UNITED STATES PATENT AND TRADEMARK OFFICE

APPLICATION NO.	FILING DATE	FIRST NAMED INVENTOR	ATTORNEY DOCKET NO.	CONFIRMATION NO.
10/659,655	09/10/2003	Barry M. Thompson	6956.07	3659

Office Action Summary

DETAILED ACTION

FIG. 1

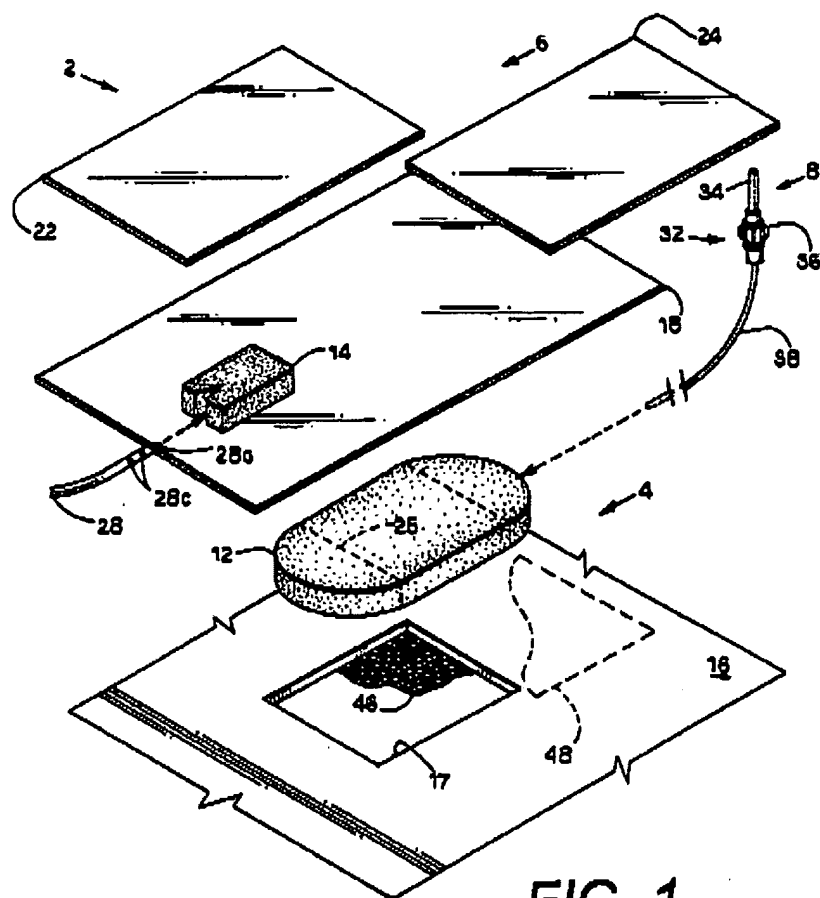
Claims 1 and 8-11 are rejected under 35 U.S.C. § 102(e) as being anticipated by Zamierowski (US 6,071,267 A).

Regarding claim 1, Zamierowski teaches an evacuation apparatus (2) for removing gaseous byproducts or noxious vapors comprising:

a head (18, 22, 24) substantially defining a plenum having an outer surface (22, 24), said plenum having an inner periphery defining a generally central opening (upside down cavity created directly over wound), said plenum having an opening in said outer surface (22, 24) adjacent to the inner periphery (20a, 20b);

a plenum support (12) for preventing the plenum from collapsing when a low pressure is established therein;

a fluid source nozzle (32) adapted to guide a fluid to the head (18, 22, 24); and
a vacuum nozzle (28) adapted to guide a fluid from the head (18, 22, 24)(see figures 1 and 3, below).

FIG. 3

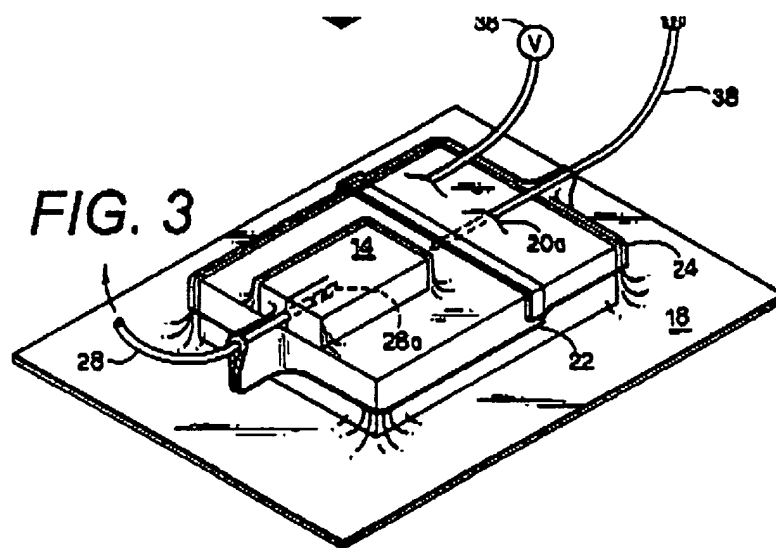
a manifold barrier, a baffle, the fluid being particle-free air or inert gas, the structure providing for unidirectional laminar airflow (not possible as fluid traveling from inlet (32) enters into the porous structure (12) and becomes diffuse), or the central opening defining a 360 degree arc.
